Construction Division
Additions & Alteration Charges Approval Form

ATR on Quality Control Check Report. (Apartments)

Quality Control Check Report. Stage: After Finishing Stage II (Apartments)

Details of Additions & Alterations

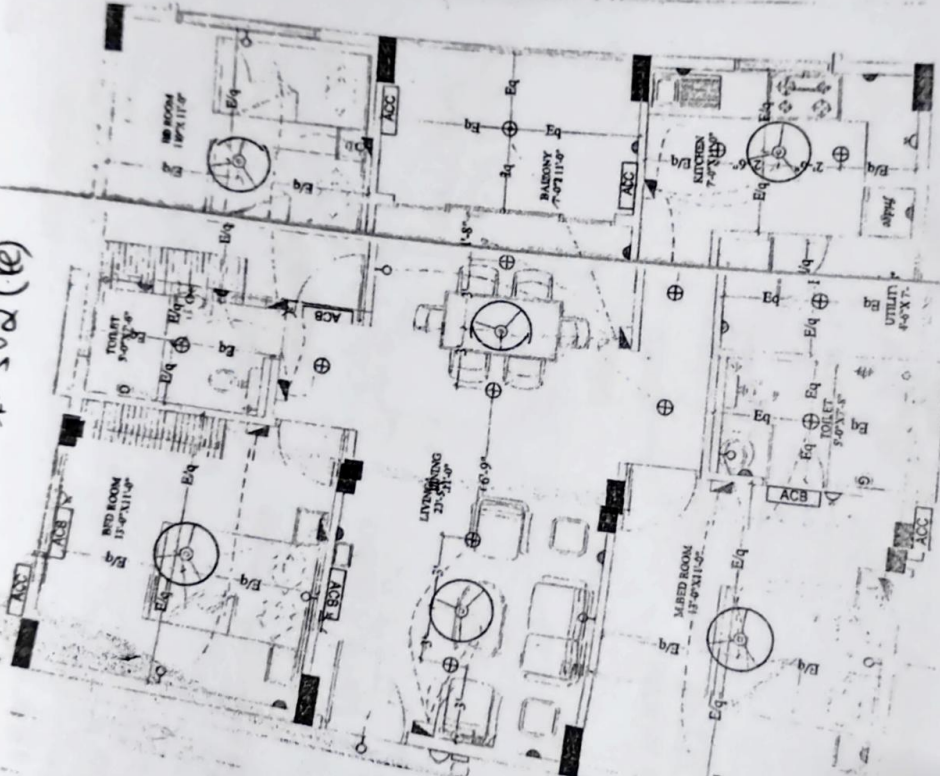
Remarks

Note: 1) In G. Bed AC point was missing.

2) In M-Toi Keyser Switch board was not provided.

QC-A-1 BLOCK-ELECTRICAL P

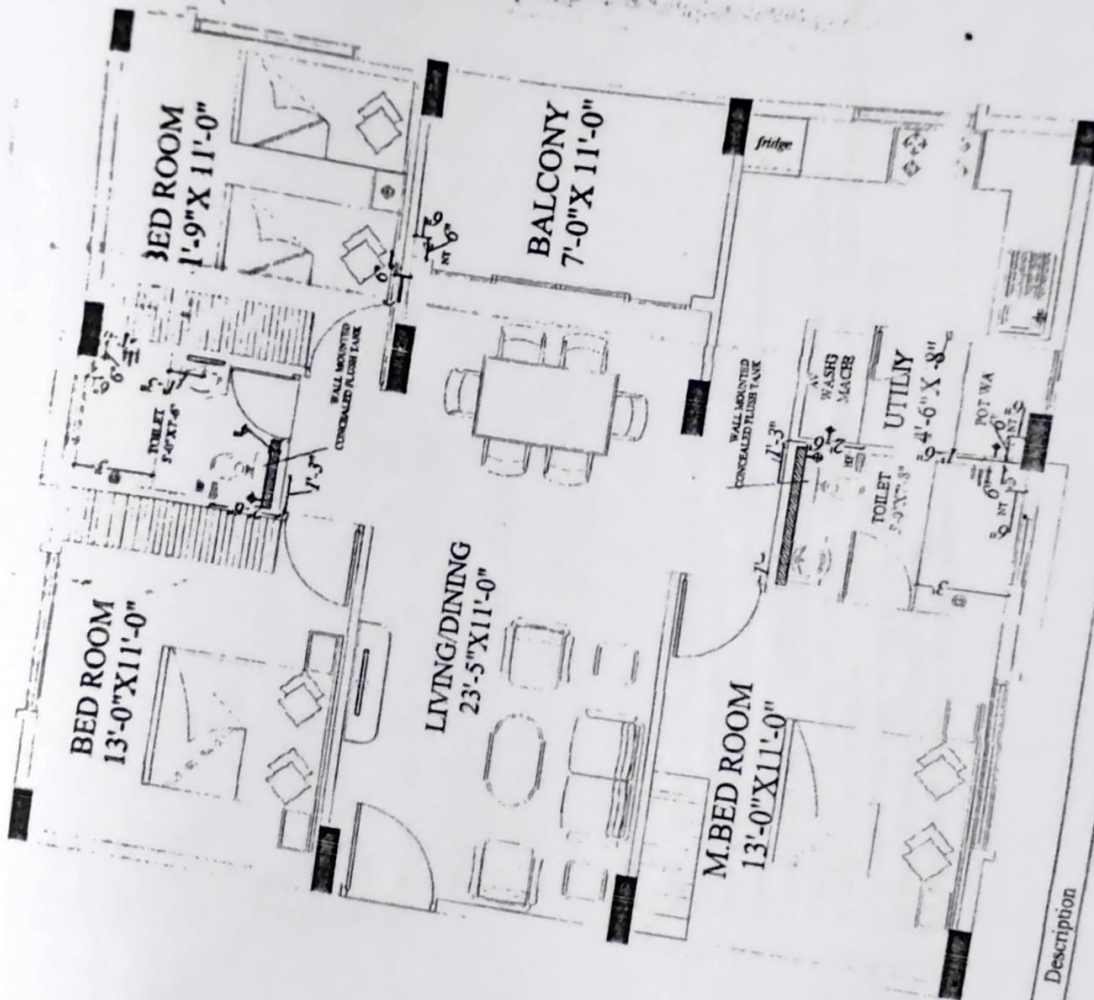
Changes in electrical points: (mark on plan)

1) Balcony one A.C. point
